**ENVIRONMENTAL (SEPA) DETERMINATION OF
NON-SIGNIFICANCE - MITIGATED (DNS-M)**

PROJECT NUMBER: LUA18-000665, PP, SA-A, CU-A, ECF, MOD

PROJECT NAME: Sapphire on Talbot

ENVIRONMENTAL REVIEW COMMITTEE REPORT

PRELIMINARY GRADING & DRAINAGE PLAN

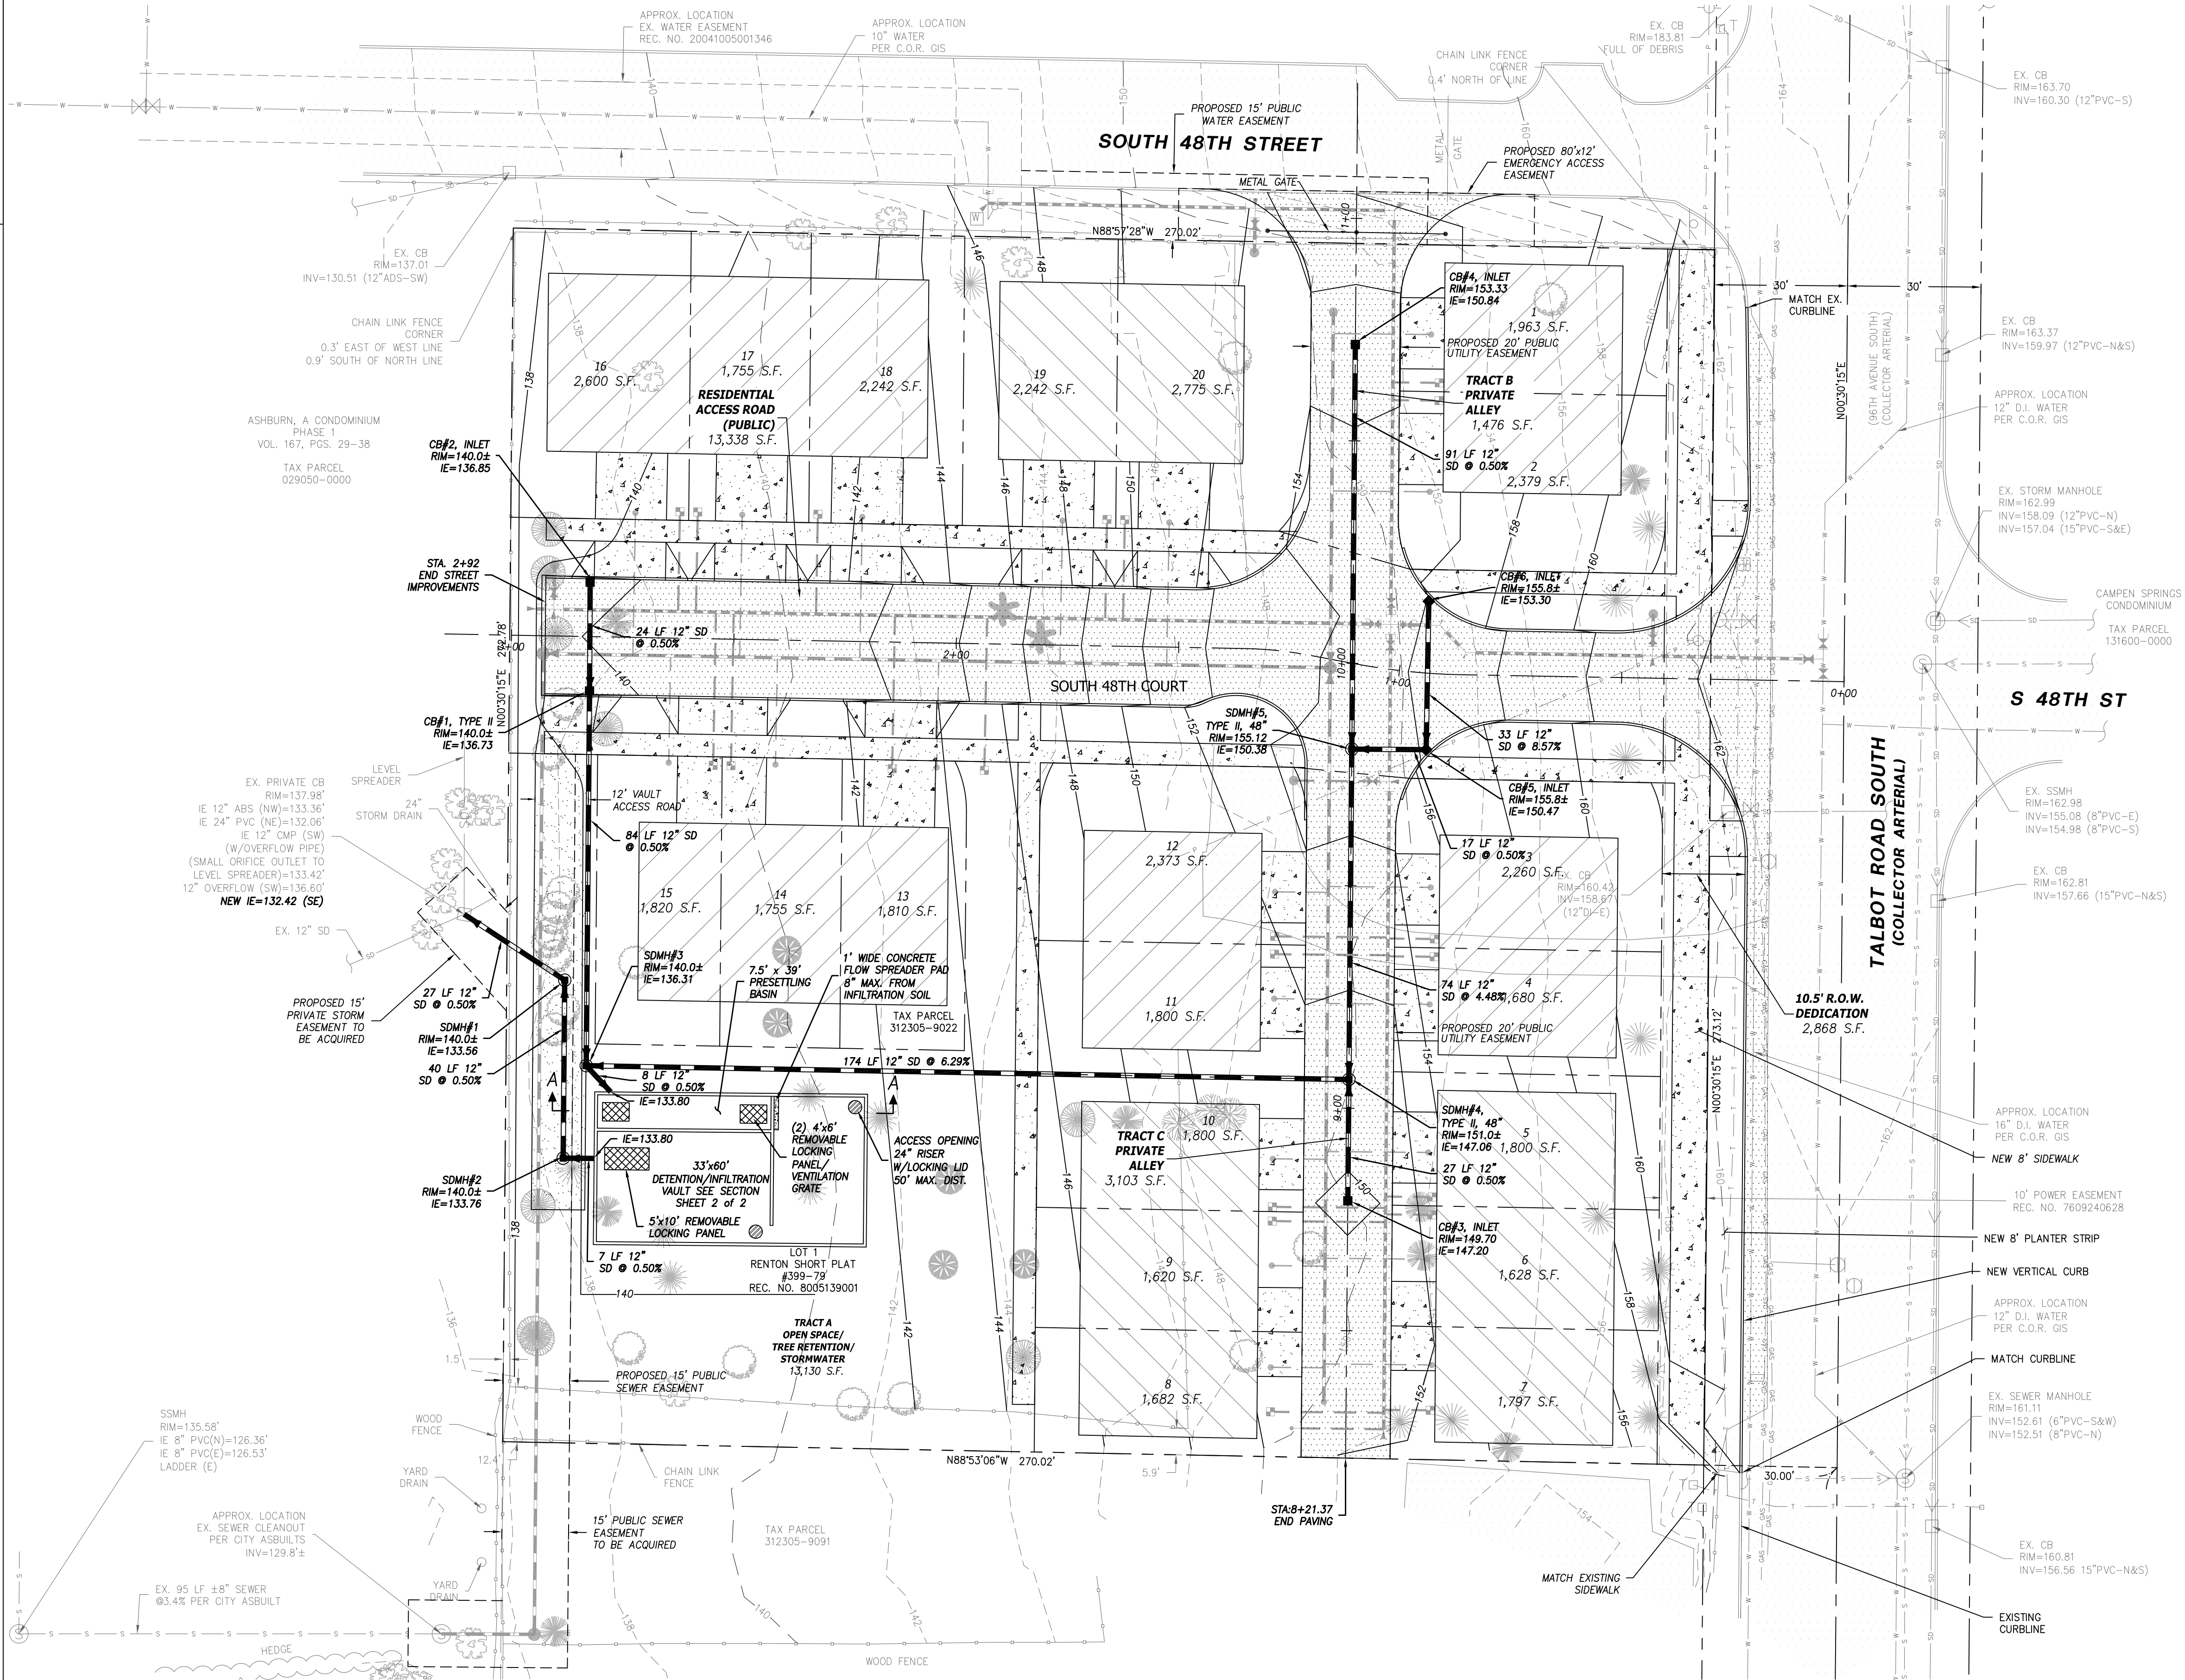
- d. ***There is a storm drain line and catch basin located within the property frontage. Storm drainage improvements along Talbot Road South are not addressed in the Civil Plans or TIR. Storm drainage improvements along all public street frontages are required to***

PRELIMINARY SEWER & WATER PLAN

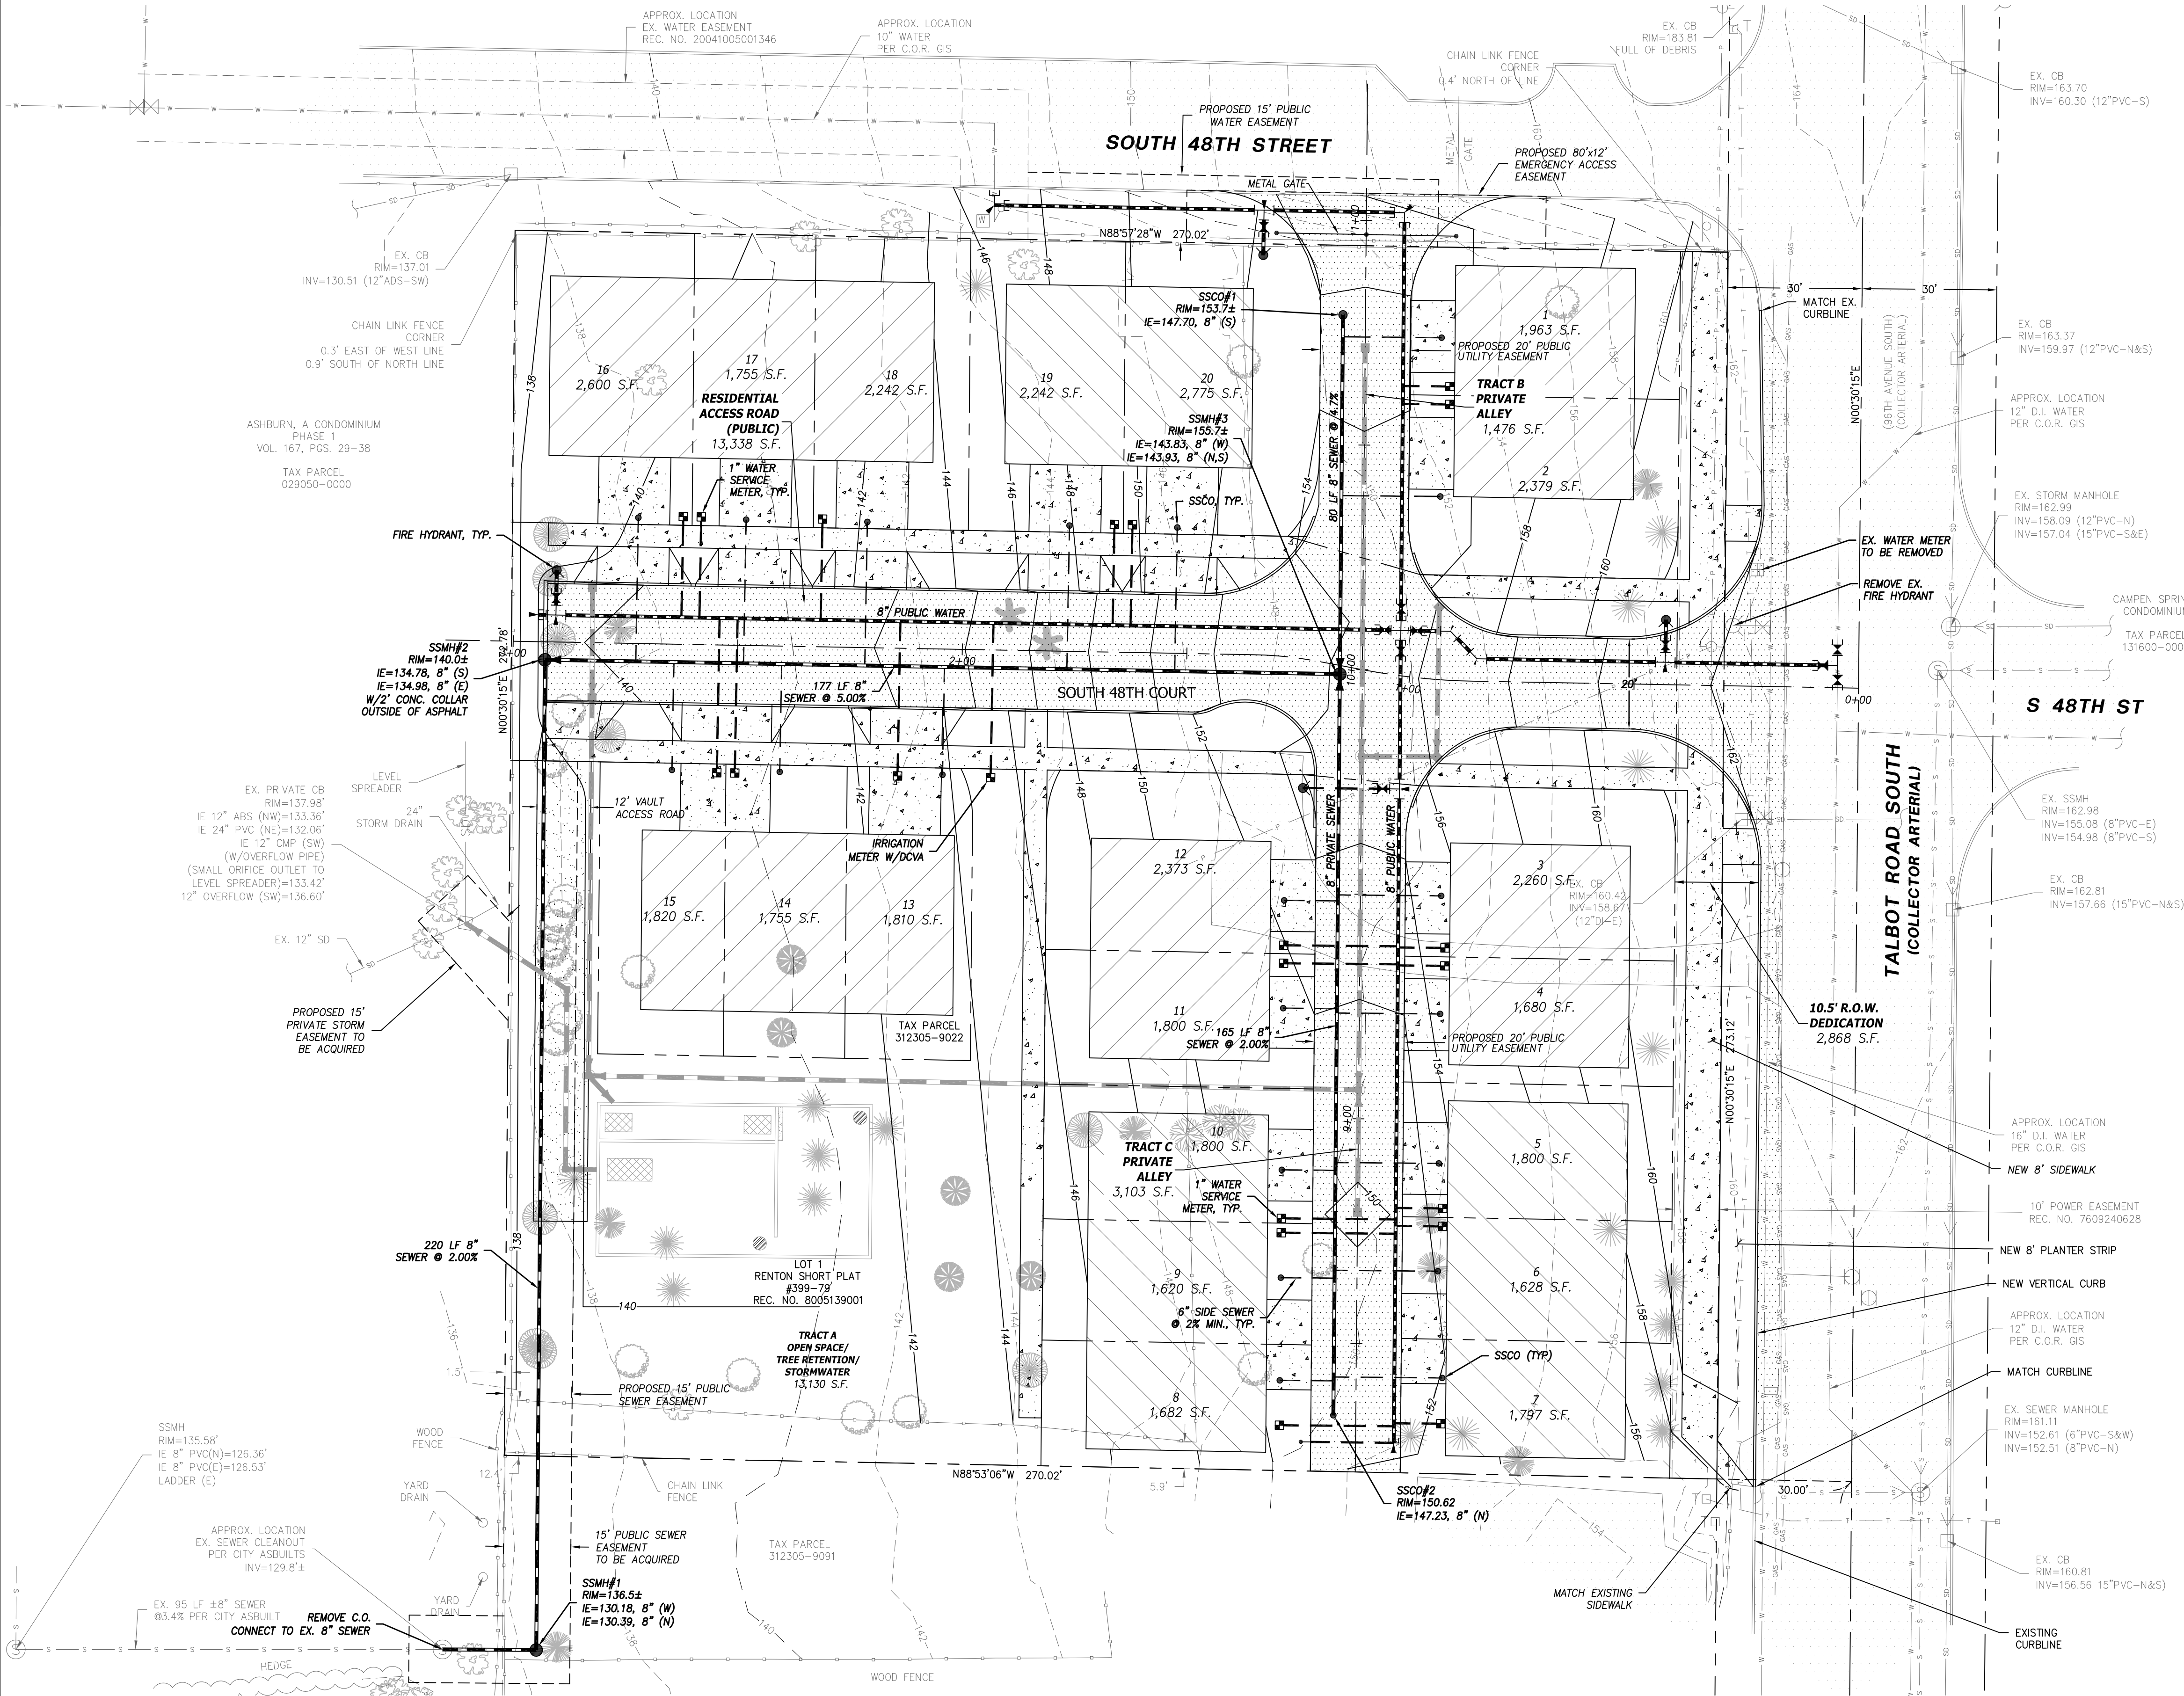
- a. ***The water main improvements as shown on the preliminary water plan prepared by Encompass Engineering & Surveying dated 10/29/18 which were submitted with the land-use application showed the new mains to be 8-inch in diameter. The minimum water main size required for fire flows above 1,000 gpm and up to 2,000 gpm is 10-inch in diameter.***

- a. Installation of on-site water mains, minimum 10-inch in diameter within the north/south and east/west interior access roads as shown on the preliminary water plans submitted with the land-use application. The new water mains shall be connected to the existing 12-inch water main in Talbot Rd S and also to the existing 10-inch water stub in S 48th St along the north property line.
